## **Rother District**

### **Civil Parking Enforcement proposals – Informal consultation**

### **East Sussex County Council 2018**

Julian Lockett  
Chair, Planning Committee  
Rye Conservation Society  
3 January 2019

Hastings

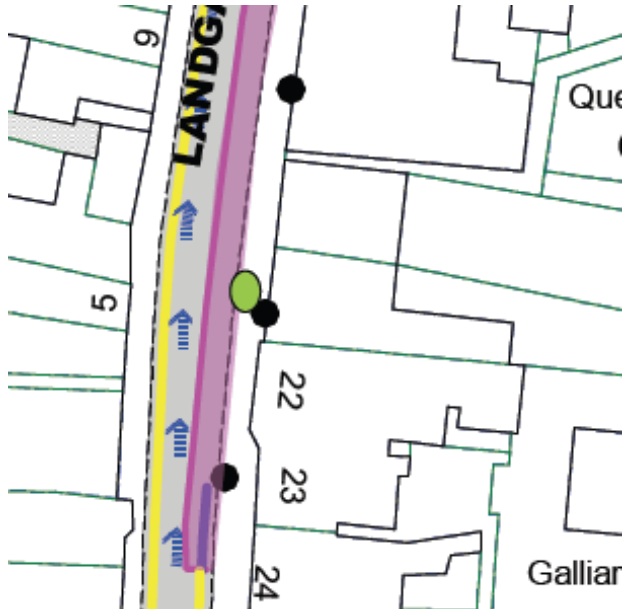
Along the south side of the High Street between Hilders Cliff and East Street, the pavement is narrow and a pavement extension may be needed, as used on Hastings High Street (see below).

This section of the High Street pavement would also benefit from having the existing bollards removed. With more rigorous enforcement of parking, the need for them is reduced and it would ease movement of pedestrians.

Site A      21/22 Landgate

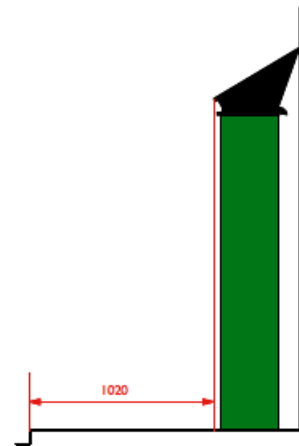
Location will be determined by interface with pavement drain and base plate to pay-and-display machine. Machine will be visible from side window of No 21 or in front of window to No 22.

Site E      106/107 High Street

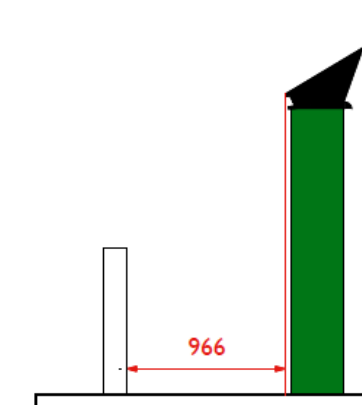
Although in all cases examined the resultant pavement width is reduced, where it is below the recommended width of 1200mm the Society does not believe that it is sufficient to make the locations unacceptable. The location at 106/107 High Street does however need to be reconsidered.

This location would require the removal of the café wall display and, because of the bollard, people using the pay-and-display machine would obstruct the pavement.

This location faces north and the solar unit may not operate.

**Site F      100 High Street**

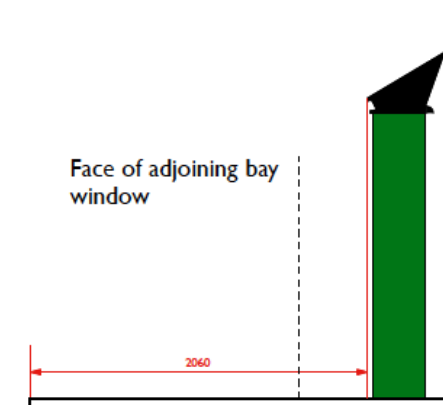
This location faces due north so the solar-powered unit may not function.

Site H 13/14 Market Street

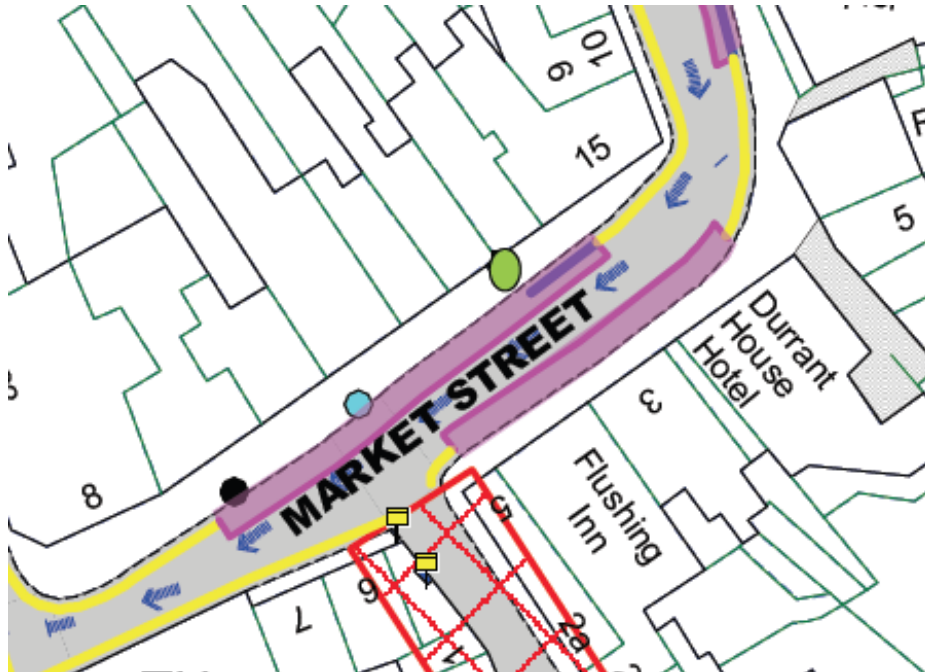
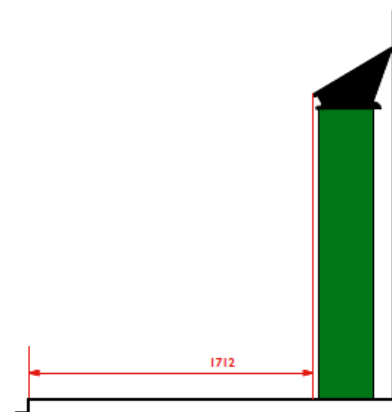
Location of pay-and-display machine will be determined by pavement gutter and water-meter cover.

Site J      25/26 High Street

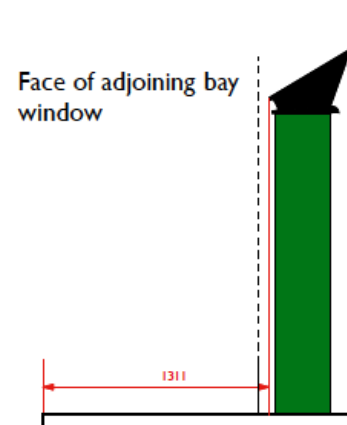
Possible clash with base fixing plate and pavement gutter.

Additional solar panel.

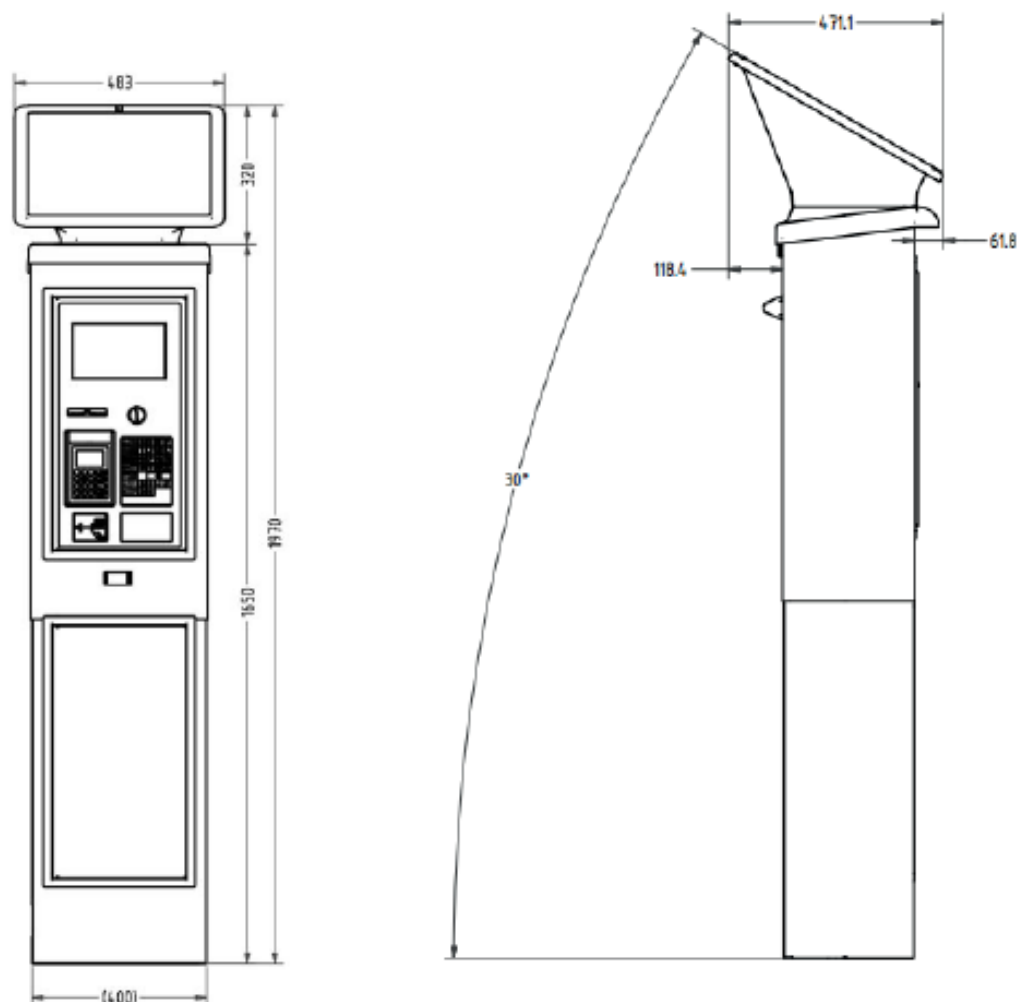
Effective use will depend on geographical location and orientation.
